JUNE 21, 2019 BOARD OF COUNTY COMMISSIONERS ORANGE COUNTY, FLORIDA ADDENDUM NO. 3, IFB Y19-754-RC ORANGE COUNTY FIRE RESCUE FIRE STATION #30 HVAC REPLACEMENT

ORANGE COUNTY FIRE STATION #30 **HVAC REPLACEMENT**

M-101

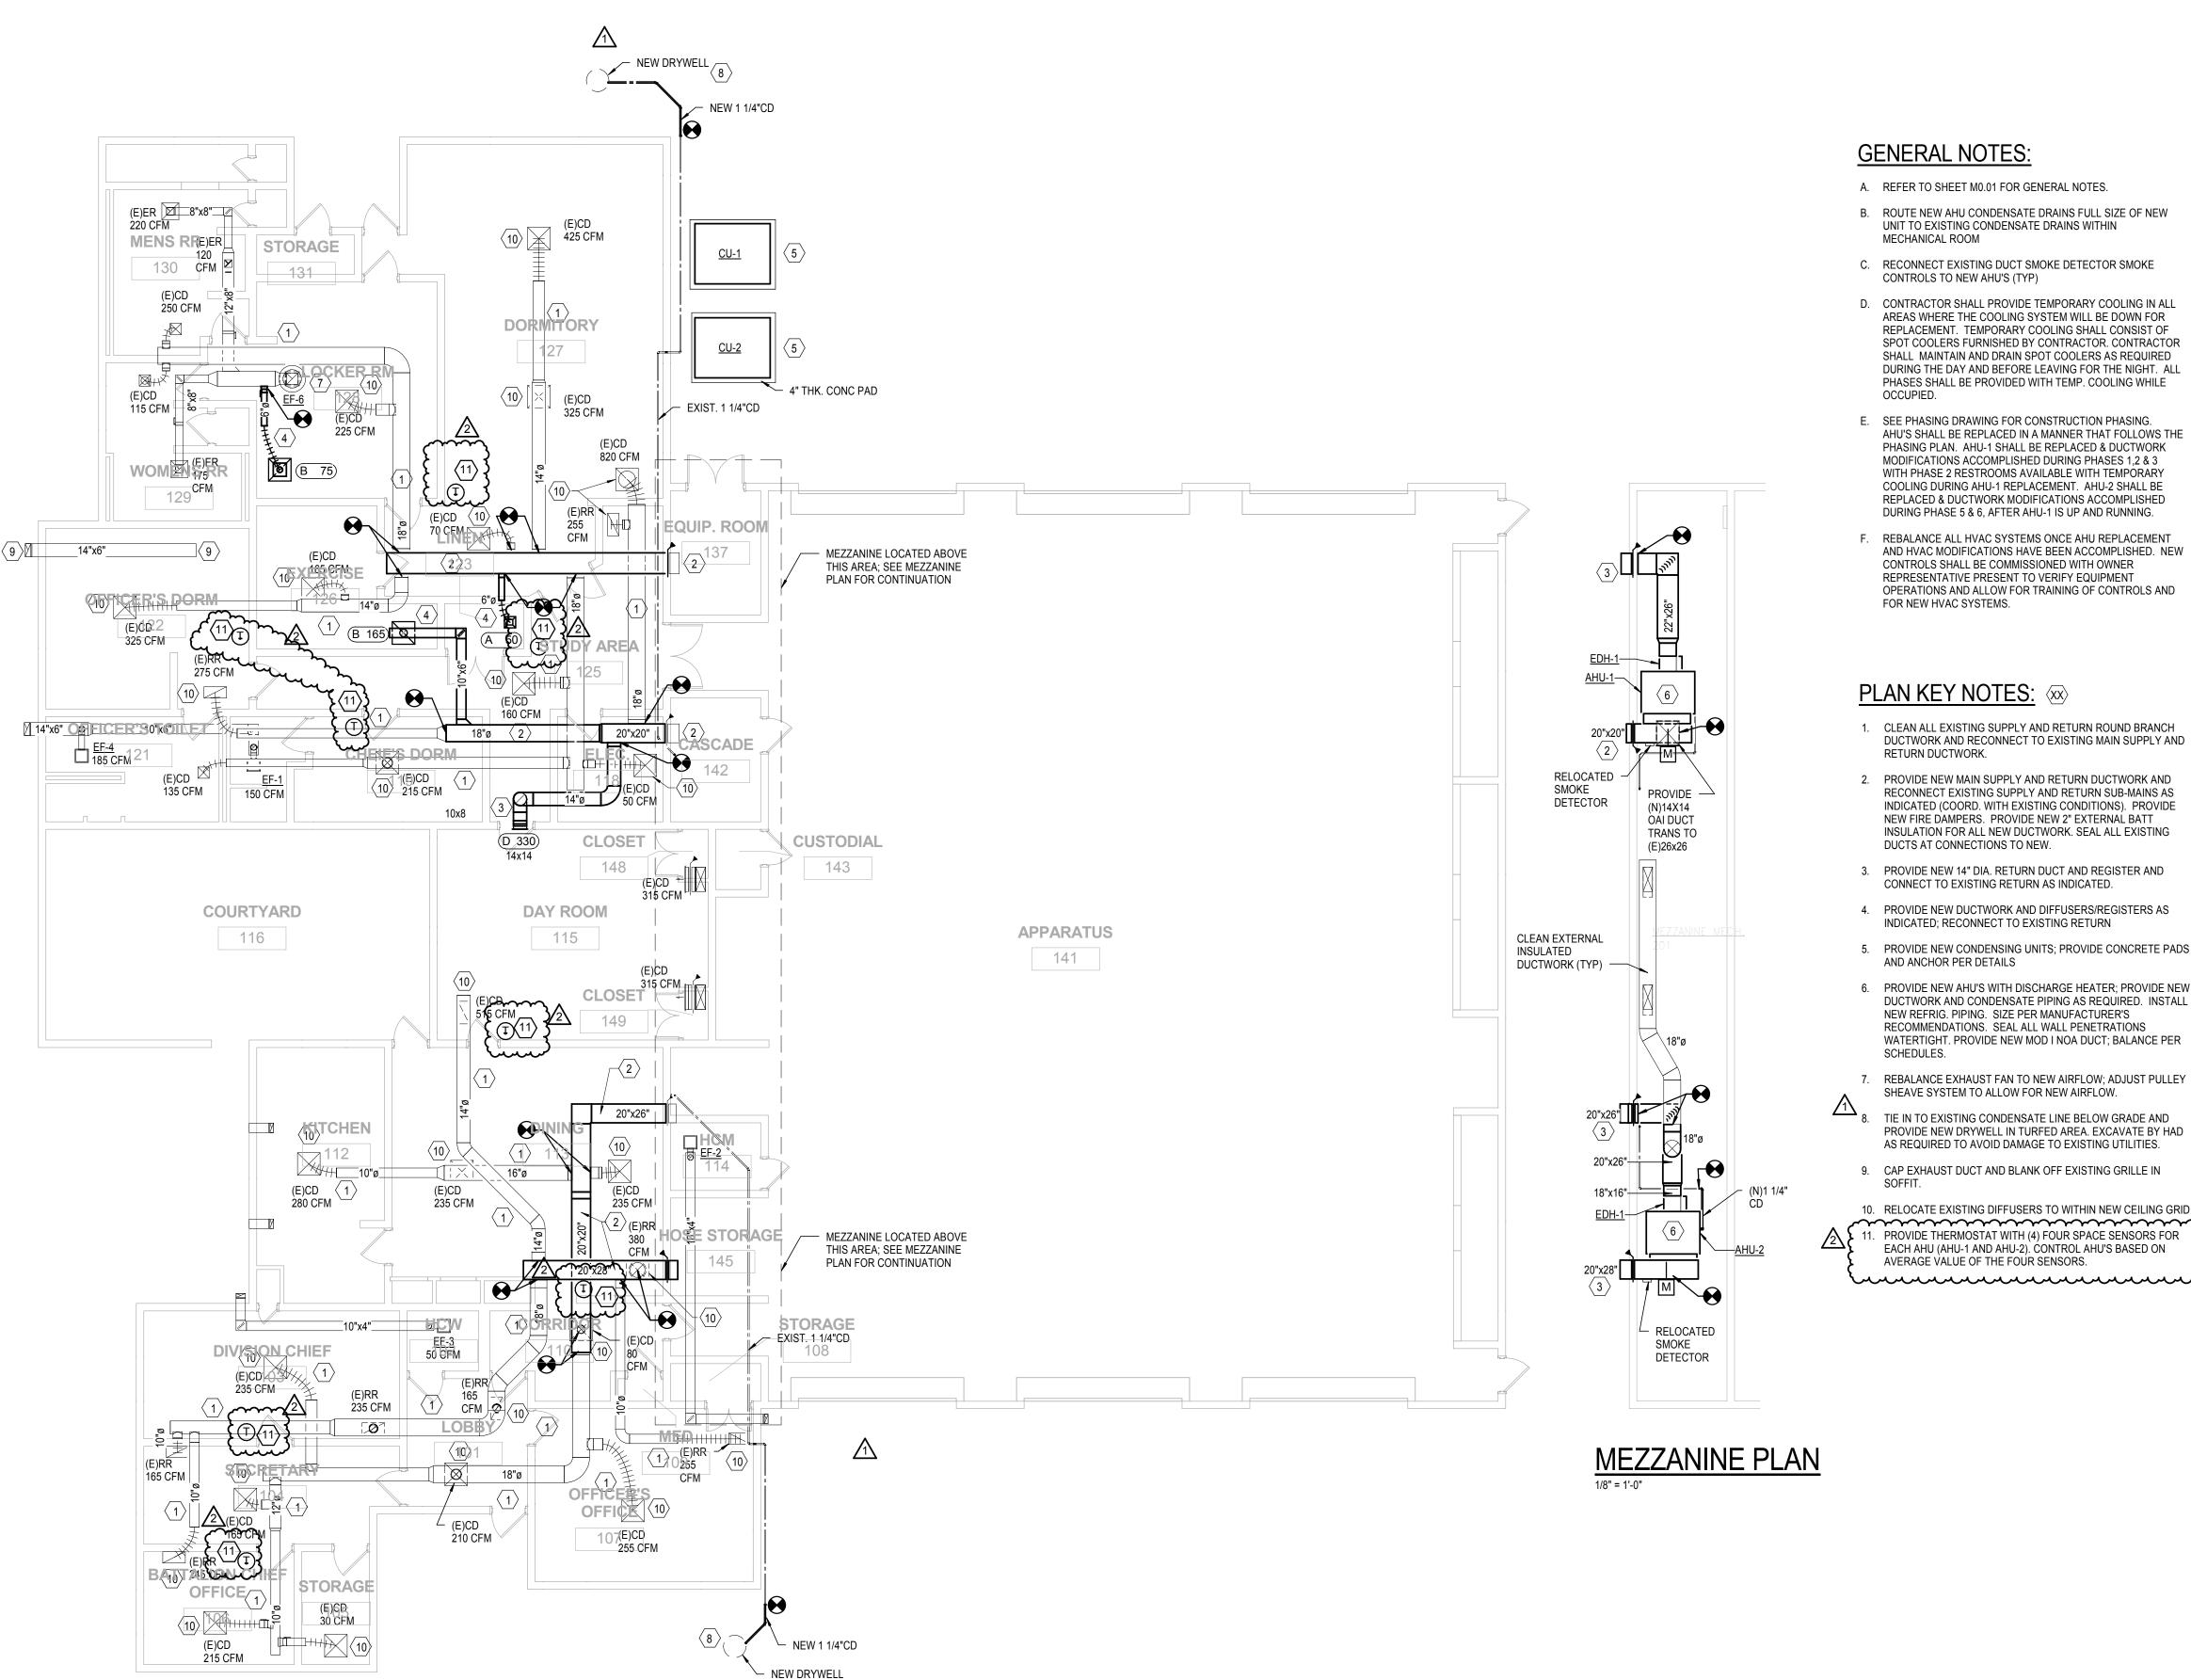
a. Please see revised mechanical drawing 'M-101' which clarifies thermostat temperature sensor locations.
